LOCKHEED AIRCRAFT CORP.		ENGINEERING STUDY <input type="checkbox"/>		CHANGE PROPOSAL <input checked="" type="checkbox"/>		LAC-98				
DATE 4-3-61		AFFECTS : WSPO <input checked="" type="checkbox"/>		PROJECT <input checked="" type="checkbox"/>						
NAME OF MAJOR COMPONENT AIRPLANE		PART OR LOWEST SUBASSEMBLY FUEL PUMP		PART NO. & MODEL OR TYPE						
TITLE OF PROPOSAL : FUEL SYSTEM REVISION										
NATURE OF PROPOSAL : SEE PAGE 2										
REASON FOR PROPOSAL : 1. To improve reliability of the existing hydraulically driven fuel boost pump by replacing the present chip catcher with a 200 mesh strainer. 2. To reduce the possibility of engine flameout due to loss of fuel pressure particularly at high altitudes by providing an electrically driven fuel boost pump as backup for the existing hyd. driven pump. The new pump will be controlled by the pilot and is to be turned on for all operations above 50M ft.

NATURE OF PROPOSAL:

Change Proposal

FUEL SYSTEM DIAGRAM

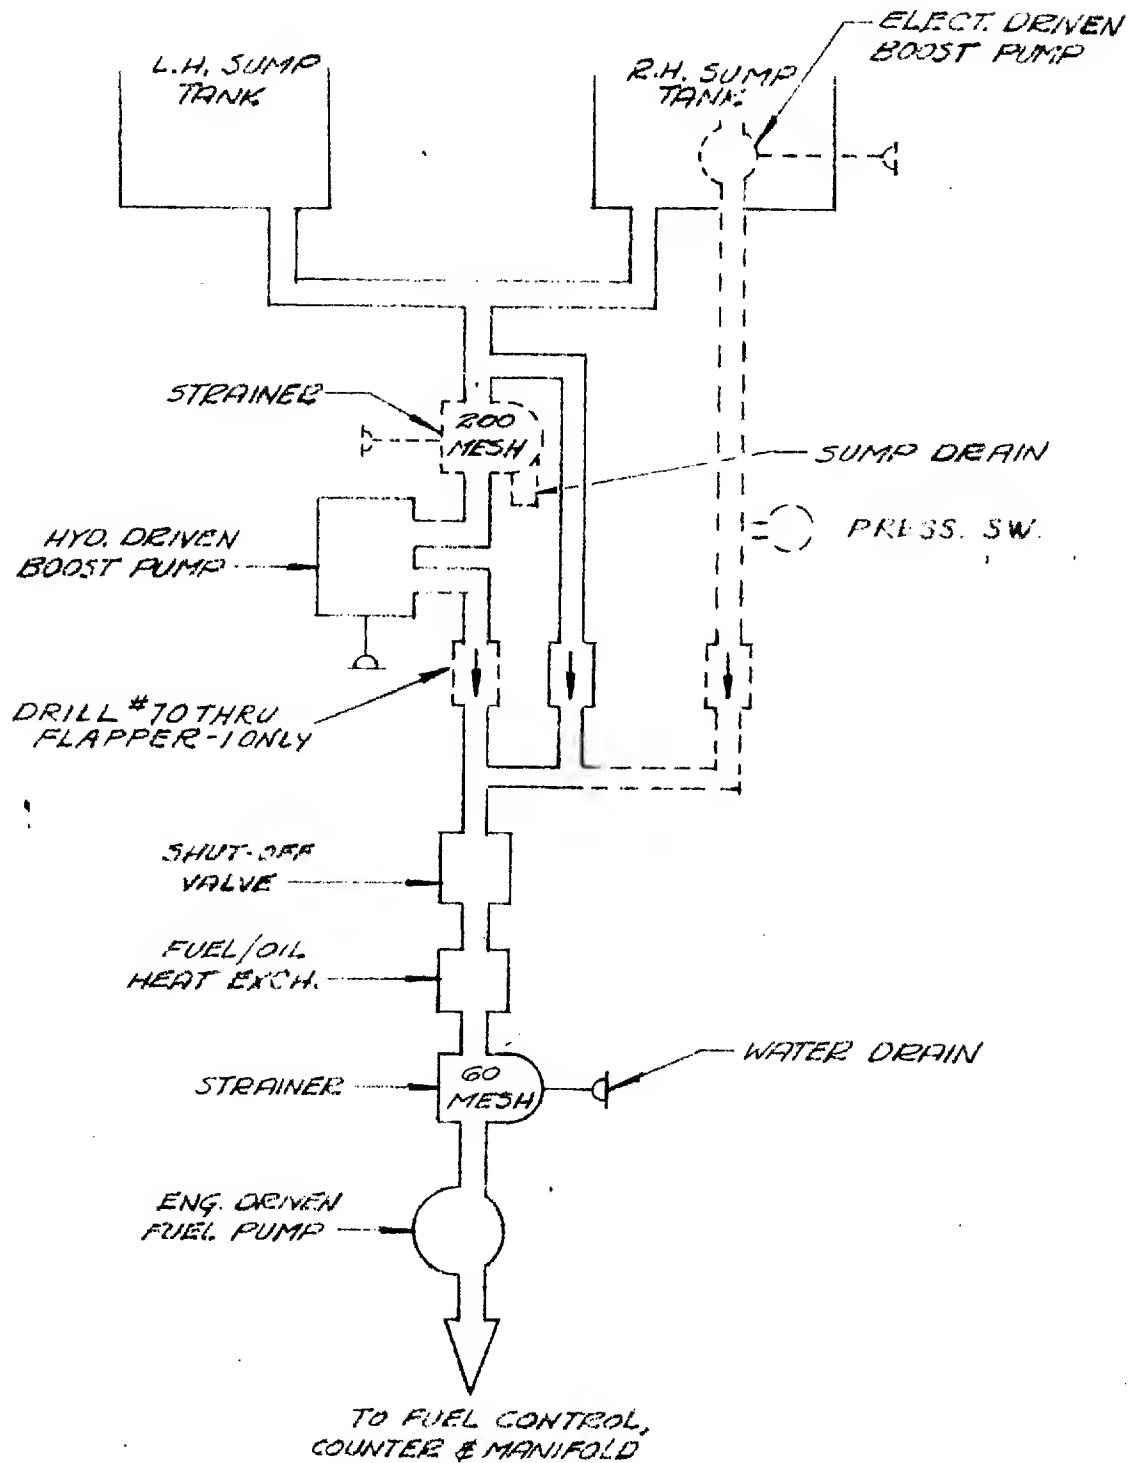
1. Modify the fuel system on all aircraft (except serials 342 & 358)* as follows:
 - a. Replace the existing Chip Catcher (P/N H-80) with a 200 mesh strainer.
 - b. Install a submerged A.C. electric motor driven boost pump in the right-hand sump tank. Install related plumbing to connect pump in parallel with the existing boost pump and bypass line. This includes the addition of two new check valves; one in each boost pump fuel out line, and a pressure switch between the check valve and the new pump (see attached diagram).
 - c. Replace the existing sump tank overflow light in the cockpit with a fuel pressure indicator light (elec. boost pump only) and install pilot's control switch. Install power relay on Q-bay "CB & Relay" panel and install system wiring.
 - d. On all aircraft remove the overflow float switch from the sump tanks.

SHOWING ADDED ELECTRICALLY DRIVEN
 SUBMERGED BOOST PUMP & 200 MESH STRAINER
